RI DEPARTMENT OF ENVIRONMENTAL MANAGEMENT
 OFFICE OF WATER RESOURCES
 FRESHWATER WETLANDS PROGRAM
 APPROVED WITH CONDITIONS AS
 SPECIFIED IN THE LETTER OF APPROVAL
 DATED: FEB 22 2024 FILE #: 22-0474
 NO CHANGES ALLOWED WITHOUT PRIOR APPROVAL
 APPROVED PLANS MUST BE AT CONSTRUCTION SITE
Nancy L. Freeman

BRIDGE GROUP 17B
 ROUTE 7 RETAINING WALL
 BURLINGHAM CONTRACT: 00 VOLUME: 04
 GENERAL PLAN

VOLUME 05: ROUTE 7 RETAINING WALL

RIDEM FWW PERMIT APPLICATION PLANS
ROUTE 7 RETAINING WALL
SUBMISSION DATE: 09/13/2022

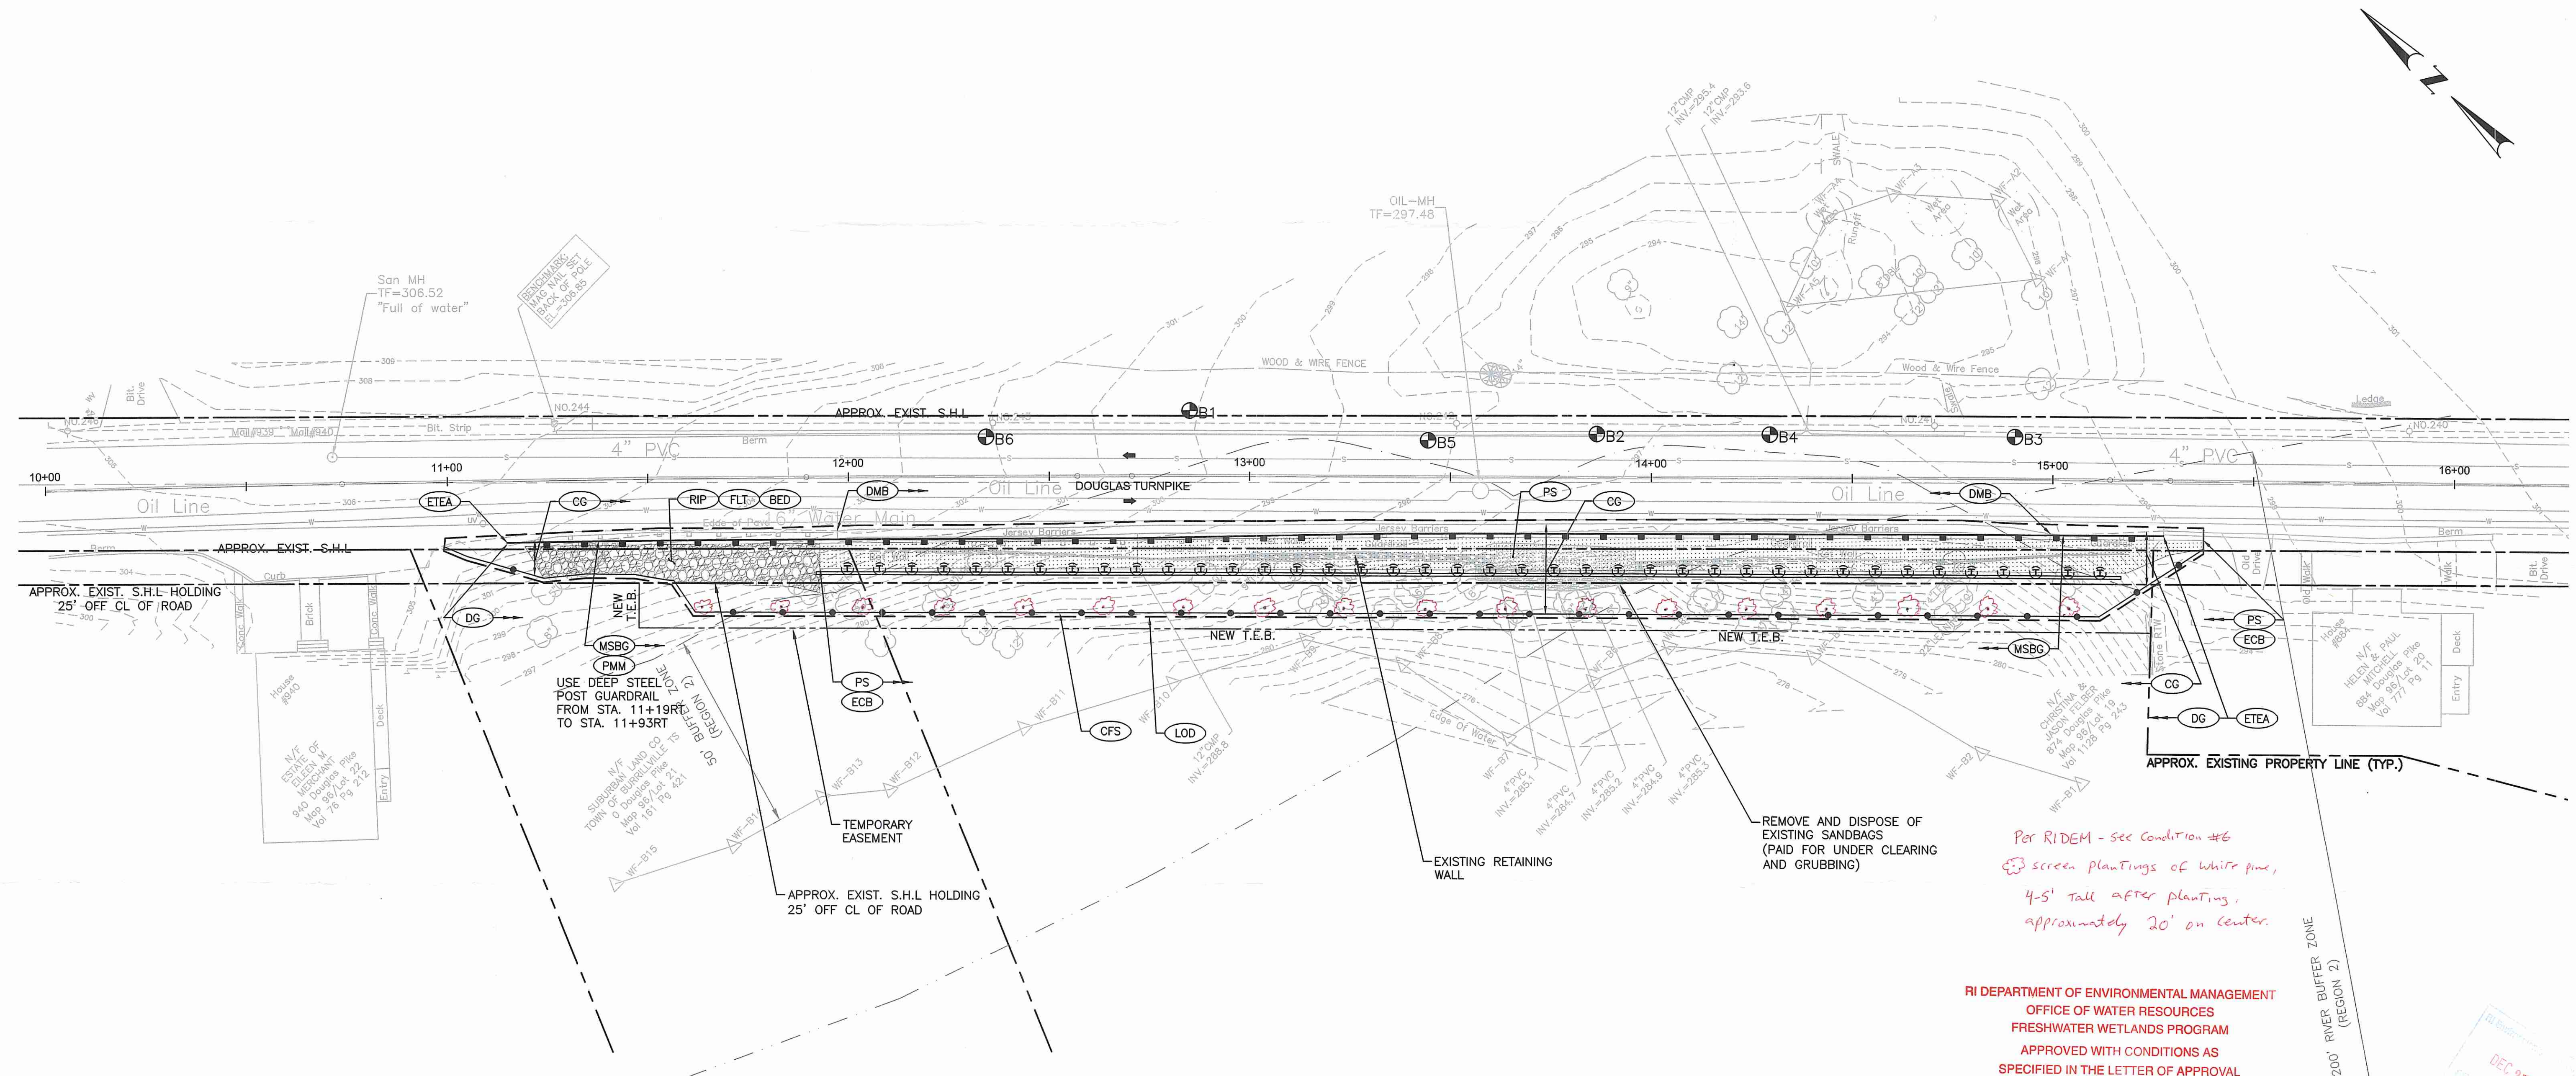
Per RIDEM - see condition #6
 screen plantings of white pine,
 4-5' tall after planting,
 approximately 20' on center.
